DAVE BAXTER  
Vice President  
Oconee Nuclear Station

SUBJECT: Duke Power Company LLC d/b/a Duke Energy Carolinas, LLC (Duke)  
Oconee Nuclear Station (ONS), Units 1, 2, & 3  
Docket Nos. 50-269, 50-270, & 50-287  
NRC Generic Letter 2004-02 Supplemental Response

**GL 2004-02 RAI Questions  
and ONS Responses**

Figure 5a-1  
Oconee LBLOCA Sump pH Response

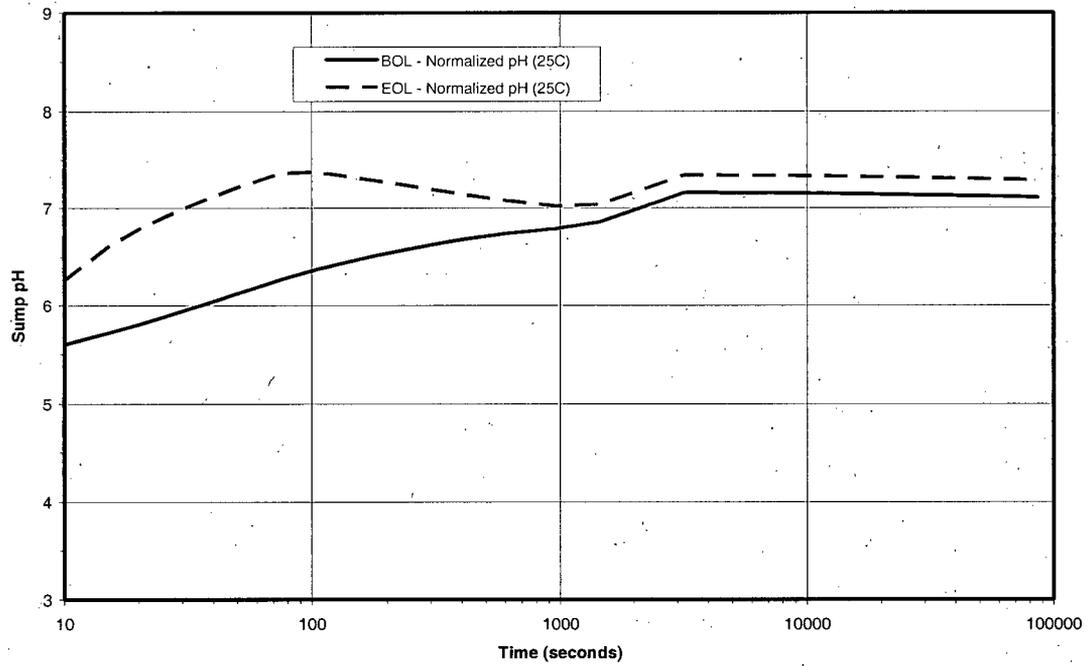
**5a. Provide the expected containment pool pH during the emergency core cooling system (ECCS) recirculation mission time following a LOCA at the beginning of the fuel cycle and at the end of the fuel cycle.**

Calculations were performed to examine the effect of beginning of life (BOL) and end of life (EOL) boron and lithium concentrations in the reactor coolant system (RCS). Results show that the lower initial concentration of boric acid in the RCS at EOL core conditions results in higher pH values than the same analysis performed at BOL at 24 hours. Figure 5a-1 shows the time-dependent pH profile calculated based on a normalized temperature of 25 °C at BOL and EOL conditions. Swapover to the recirculation phase was conservatively assumed to occur at 1500 seconds.

The Oconee sump pH analysis shows that by 24 hours all of the water from the RCS, Borated Water Storage Tank (BWST), Core Flood Tanks (CFTs), and ECCS and all of the trisodium phosphate dodecahydrate (TSP-C,  $\text{Na}_3\text{PO}_4 \cdot 12\text{H}_2\text{O}$ ) will be in the sump pool. However, nitric acid and hydrochloric acid production due to irradiation of the water/air mixture inside of containment and the electrical cable insulation/jacket material will be a long term contributor to the pH value of the pool water. A sensitivity analysis was performed and showed that when the time range is increased, there is an insignificant change in the sump pool pH beyond 24 hours.

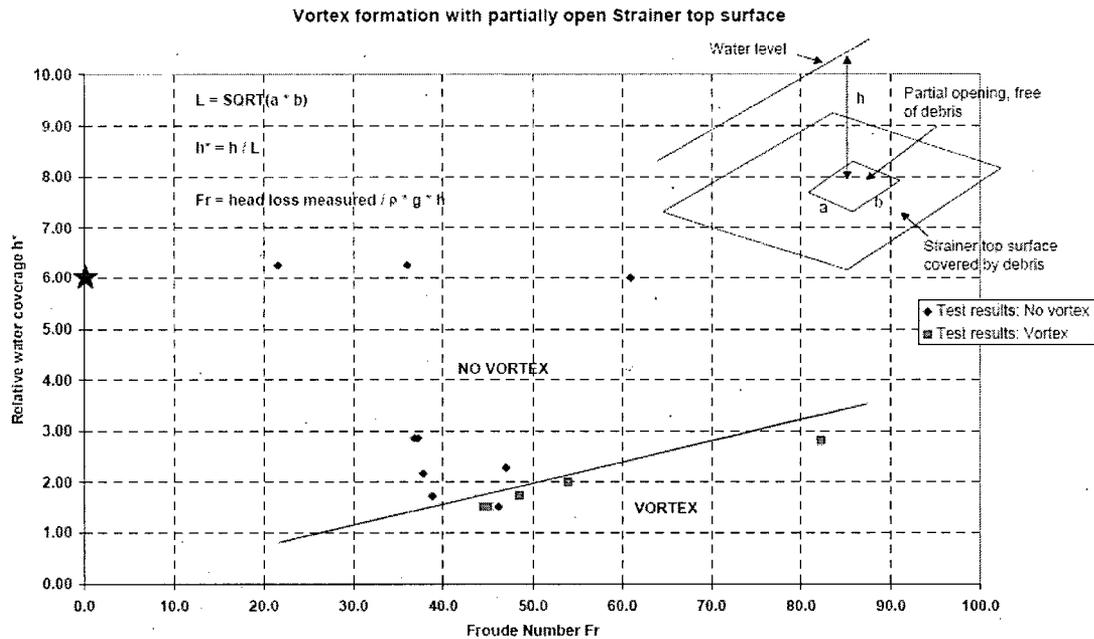
- 2. Provide the minimum submergence of the strainer under small-break loss-of-coolant accident (SBLOCA) and large-break loss-of-coolant accident (LBLOCA) conditions.**

The minimum submergence associated with a LBLOCA has been determined to be 0.9775 feet.

Oconee has not determined a minimum submergence associated with a SBLOCA. However, the minimum submergence for SBLOCA would be only 0.23 ft less than for LBLOCA due to the potential for the Core Flood Tanks to retain their contents for a period of time until the RCS pressure falls below the CFT pressure. Bounding vortex analyses for the LBLOCA scenario shows a relative submergence of 5.96 ft. (see graph in item 3 below). For the reduced flow rates and lower sump temperatures associated with SBLOCA, the Froude number (Fr) would decrease and the required relative submergence ( $h^*$ ) would be lower. Accounting only for the reduced submergence present in SBLOCA, the relative submergence is  $h^* = (0.9775 - 0.23) \times .305 / 0.05 = 4.56$ . From the same graph, the relative submergence for SBLOCA clearly lies in the region where vortexing is not expected.
